APPENDIX C6 COMMENTS RECEIVED

Comments received on EIA Report to be included in the Final EIA Report

ACCEPTANCE OF THE FINAL SCOPING REPORT FOR THE PROPOSED KOPPY ALLEEN SOLAR PV FACILITY AND ITS ASSOCIATED ELECTRICAL INFRASTRUCTURE ON PORTION 5 OF THE FARM KOPPY ALLEEN 83 WITHIN THE RENOSTERBERG LOCAL MUNICIPALITY IN THE NORTHERN CAPE PROVINCE

COMMENTS ON THE DRAFT SCOPING REPORT FOR THE PROPOSED KOPPY ALLEEN SOLAR PV FACILITY AND ITS ASSOCIATED ELECTRICAL INFRASTRUCTURE ON PORTION 5 OF THE FARM KOPPY ALLEEN 83 IN THE RENOSTERBERG LOCAL MUNICIPALITY IN THE GREATER PIXLEY KA SEME DISTRICT MUNICIPALITY, NORTHERN CAPE PROVINCE

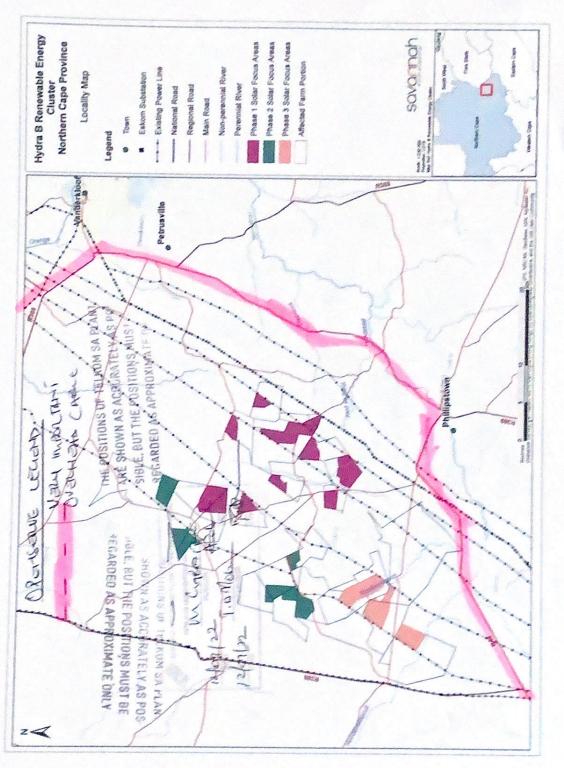
Our Client (OPENSERVE)'s infrastructure is affected by this proposal and the routes are marked in PINK on attached sketch as accurately as possible. We did our utmost to ensure that we indicate our route as accurate as possible and should you discover any of our cables that are not on the sketch please stop and contact us immediately to arrange a site meeting. Please make use of pilot holes in order not to damage our infrastructure. Therefore, any damages occurred during construction of work will be repaired at the customer's account. Consequently, the following conditions apply:

Aerial Plant - At points of crossing, the overhead power lines should cross above the communications lines in accordance with and clearances stipulated in the Occupational Health and safety Act no 85 of 1993, Machinery regulations 20 – Crossings, and Electrical Machinery Regulations 15 – Clearance of Power Lines. If the specifications could not be met, all deviation costs will be for the applicant's account. We also refer to section 25 of Electronic Communication Act 36 of 2005.

At points of crossing, the overhead power line should cross over the overhead communication lines with a minimum vertical separation of **0.8** meters.
